GE INNOVATION POINT

Fort Point Channel Landmark District Review

October 12, 2017

DESIGN UPDATES **TABLE OF CONTENTS**

NECCO CT BRIDGE WEST FACADE DESIGN UPDATE

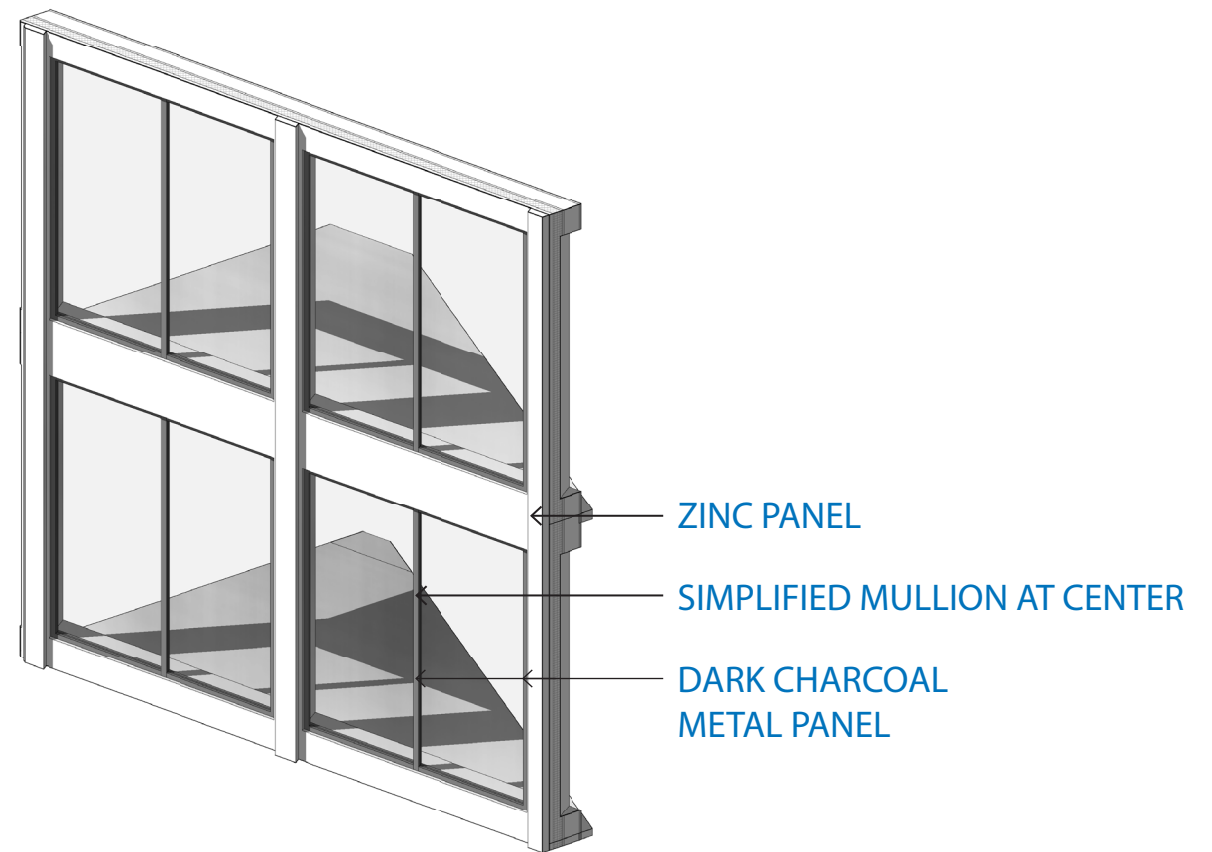
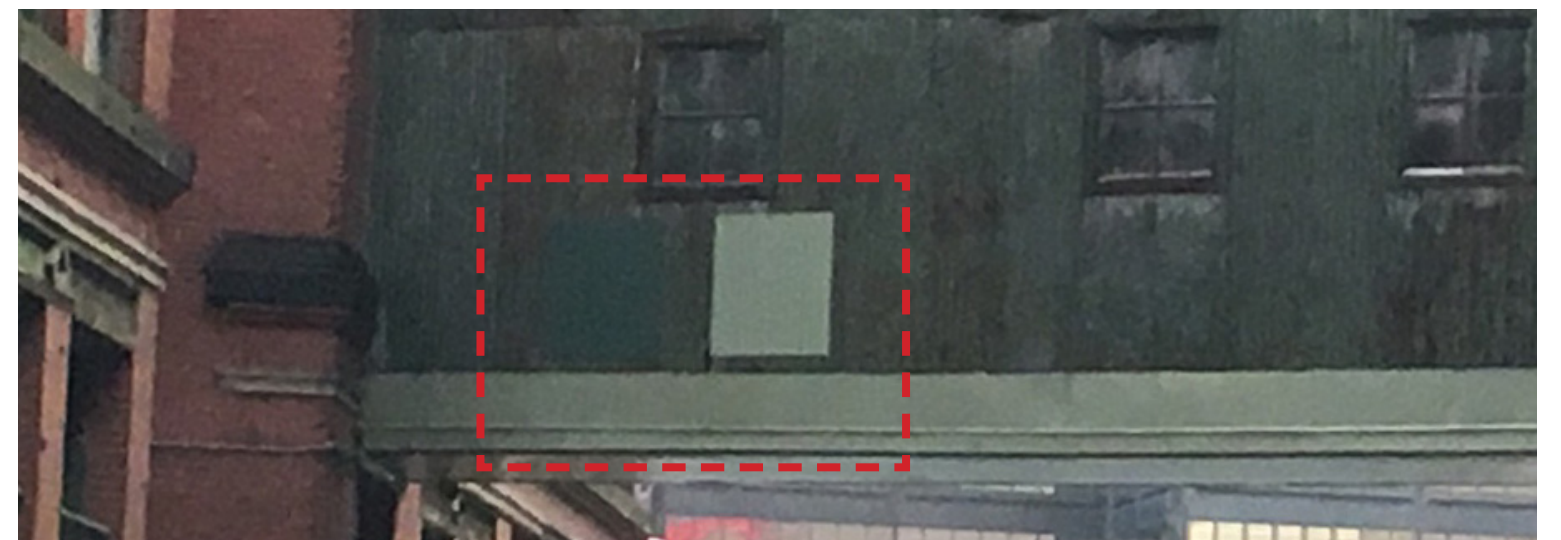
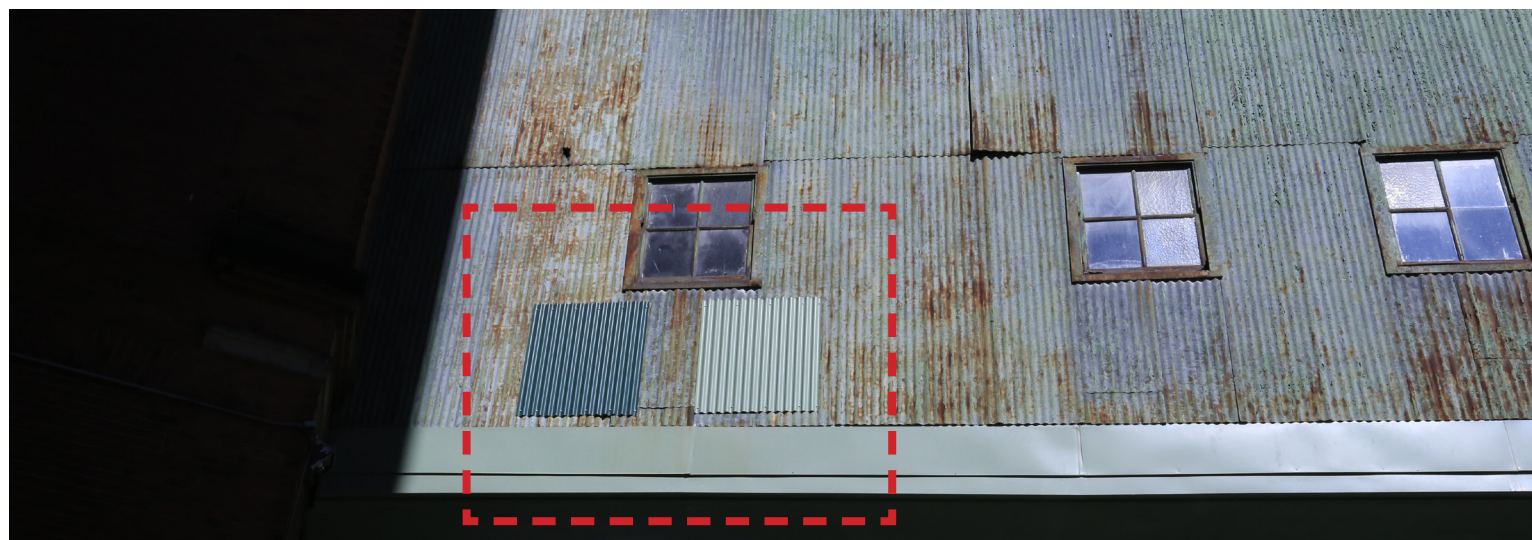
NECCO CT BRIDGE WEST FACADE - DESIGN AS PRESENTED ON 2017.07.13

NECCO CT BRIDGE WEST FACADE - CURRENT DESIGN

AS PRESENTED ON 2017.07.13

CURRENT DESIGN

ETCHED WINDOWS - EAST ELEVATION

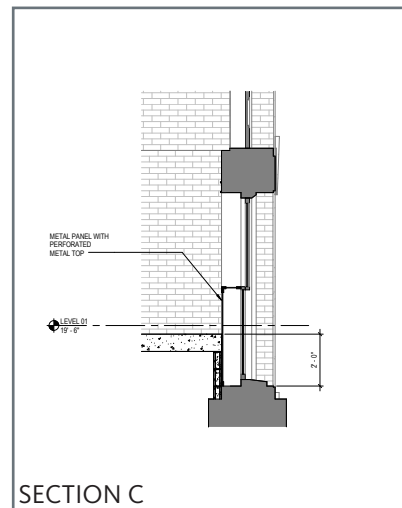
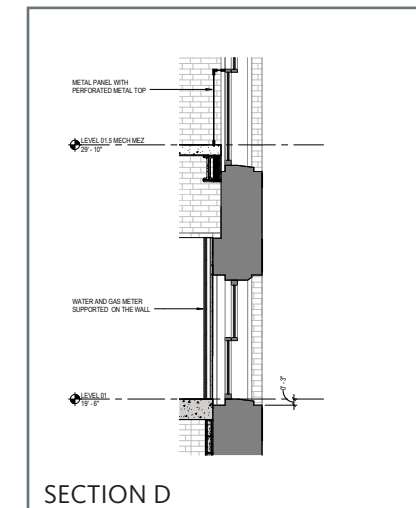
AS APPROVED ON 2016.10.05

PROPOSED

BRICKED IN
	ETCHED WITH WALL BEHIND
	FORMERLY ETCHED, UPDATED TO CLEAR
	ETCHED WITHOUT WALL BEHIND

ETCHED WINDOWS - GLASS ENCLOSURE EAST ELEVATION

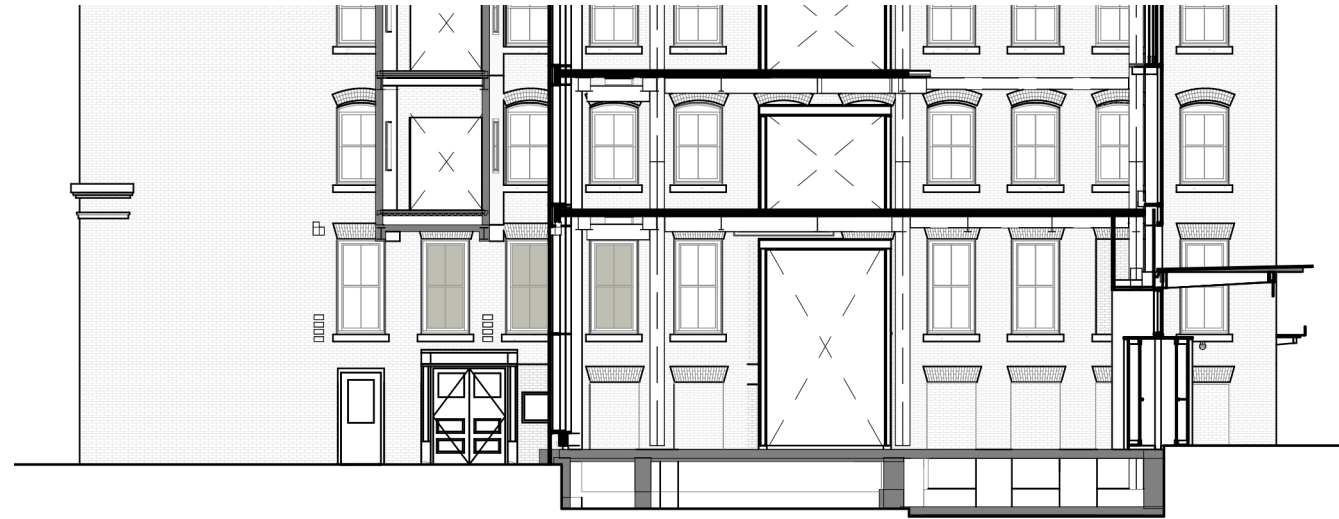
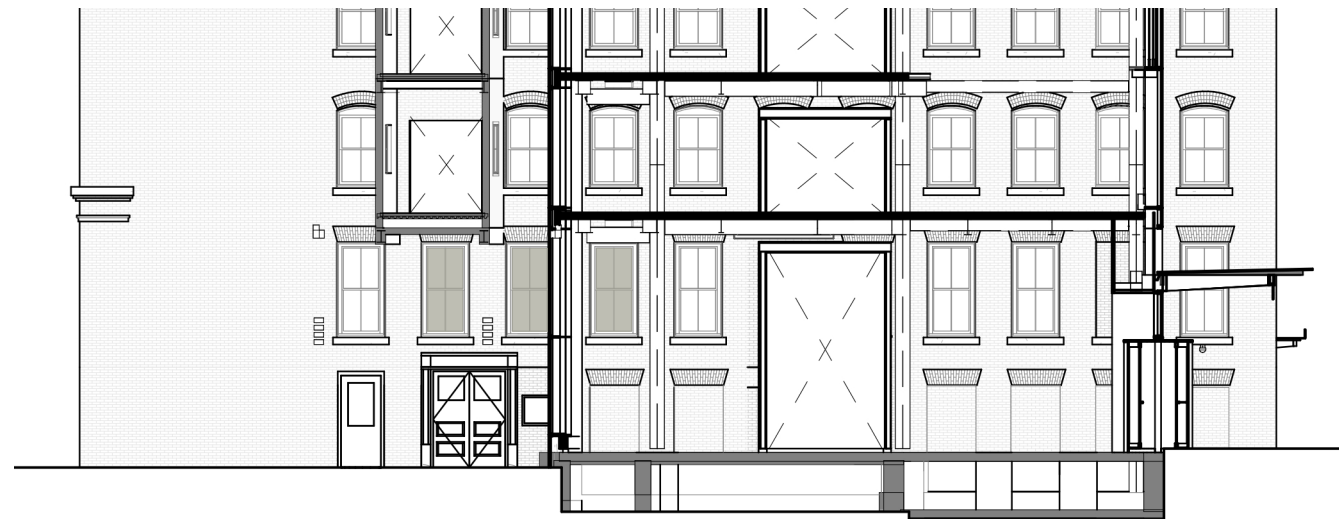
AS APPROVED ON 2016.10.05

PROPOSED

BRICKED IN
	ETCHED WITH WALL BEHIND
	FORMERLY ETCHED, UPDATED TO CLEAR
	ETCHED WITHOUT WALL BEHIND

ETCHED WINDOWS - GLASS ENCLOSURE WEST ELEVATION

AS APPROVED ON 2016.10.05

PROPOSED

BRICKED IN
	ETCHED WITH WALL BEHIND
	FORMERLY ETCHED, UPDATED TO CLEAR
	ETCHED WITHOUT WALL BEHIND
